UNITED STATES PATENT AND TRADEMARK OFFICE

Office Action Summary

This is the **Final Office Action** for application number 10/604,008 Gas Cylinder Base, filed on 6/20/03. Claims 1-32 are pending. This **Final Office Action** is in response to applicant's reply dated 10/29/04. The text of those sections of Title 35, U.S. Code not included in this action can be found in a prior Office action.

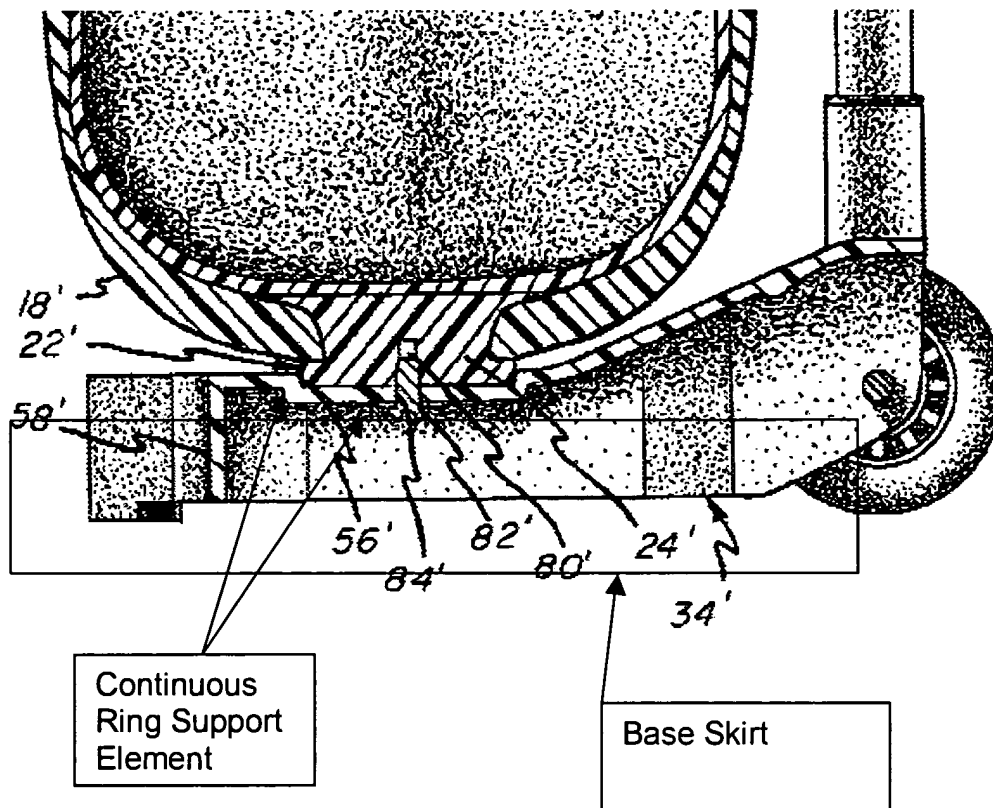
Claims 1-5, 7-10, 17-21 and 23-26 are rejected under 35 U.S.C. 102(b) as being anticipated by United States Patent No. 6508477 to Burkett to the embodiment shown by Figs. 6-9.

The patent to Burkett discloses a gas cylinder (14'), the cylinder having a base ring (22', 24') with a threaded aperture therethrough (80'), the base having a base skirt (including a portion of 42'), having a first lateral dimension, which is greater than the diameter of the cylinder (14') and a continuous ring support element (See Drawing Below), the support element which extends upwardly from the base skirt and which defines a second lateral dimension less than the first lateral dimension and a threaded fastener (82') inserted in a threaded aperture (84') therethrough in the support element and in the threaded aperture (80') of the base ring (22' 24') of the cylinder, for attaching the gas cylinder to the base by engaging the base ring of the cylinder, the fastener (82') having a point at an end which engages the base ring (22', 24').

The applicant has also argued that the Burkett reference does not show a base skirt, the ring extending upwardly from the base skirt. The drawing above has added emphasis to show that a portion of (42') is considered the base skirt, the ring extending from that bottom/base portion as clarified above, this argument also being unpersuasive.
